Report from Mr. Mat Collins of Flow Transportation Specialists regarding DEV-RO14

<b>PROJECT</b>	<b>VARIATION 1 TO THE PROPOSED DISTRICT PLAN: REZONING SUBMISSIONS</b>
<b>SUBJECT</b>	<b>ROLLESTON PACKET: PEER REVIEW OF TRANSPORT MATTERS</b>
<b>TO</b>	<b>JOCELYN LEWES; JUSTINE ASHLEY</b>
<b>FROM</b>	<b>MAT COLLINS</b>
<b>REVIEWED BY</b>	<b>IAN CLARK</b>
<b>DATE</b>	<b>7 MARCH 2023</b>

## 1 LOT 2 DP 61162 SPRINGSTON ROLLESTON ROAD, ROLLESTON, KEVLAR DEVELOPMENT LIMITED

**Figure 1: DEV-RO14 as notified in Variation 1**

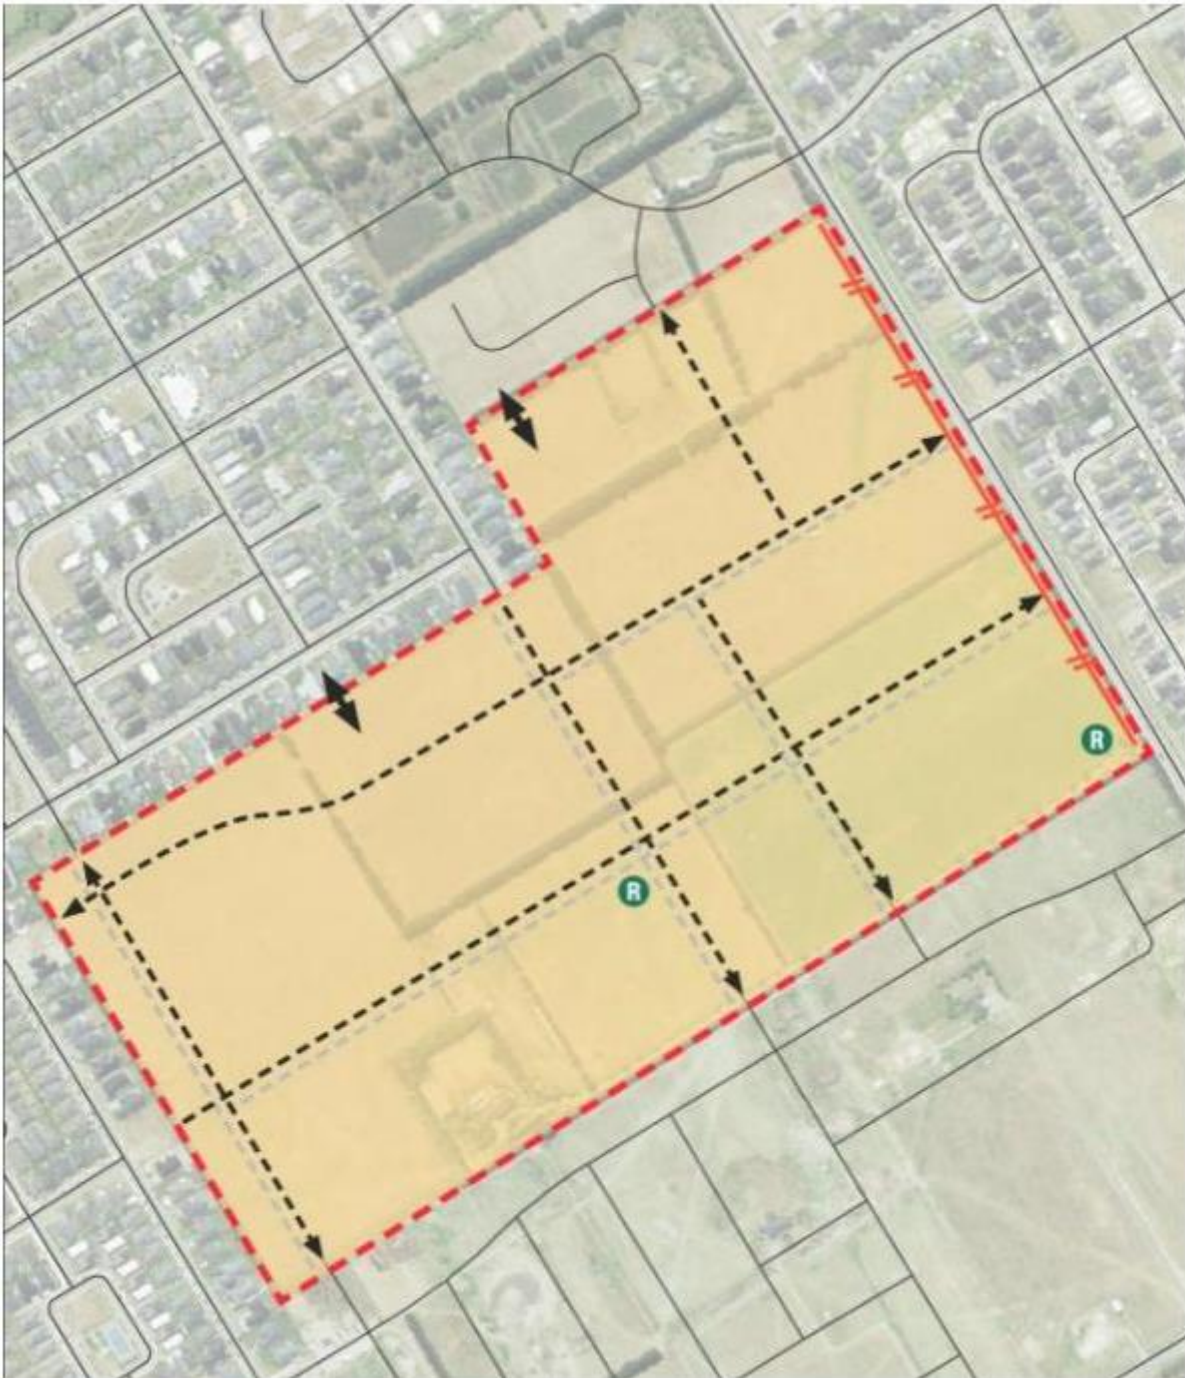
This submission seeks to delete DEV-RO14 Rolleston Development Area as notified in Variation 1 (see Figure 1) and replace it with an amended plan (see Figure 2).

Key transport differences between the notified plan and the submitters requested relief are shown on Figure 2, and summarised as

- ♦ relocation of one north/south internal road somewhat to the east
- ♦ Realignment of the northern east/west road to intersect with Selwyn Rolleston Road approximately 50m north of the Kate Sheppard intersection.

- ◆ I consider that the submitters request to relocate the north/south road is acceptable and can be adopted

- ◆ I recommend that the submitters request to realign the northern east/west road to intersect with Selwyn Rolleston Road approximately 50m north of the Kate Sheppard Drive intersection is refused. I consider that retaining the alignment to intersect with Kate Sheppard Drive is preferable for the following reasons

- ◆ the submitters request to relocate the north/south road is acceptable and can be adopted
- ◆ the submitters request to realign the northern east/west road to intersect with Selwyn Rolleston Road approximately 50m north of the Kate Sheppard Drive intersection is refused. I understand that, via resource consent application RC22175, the submitter has agreed to retain the intersection location with Kate Shepherd Drive.
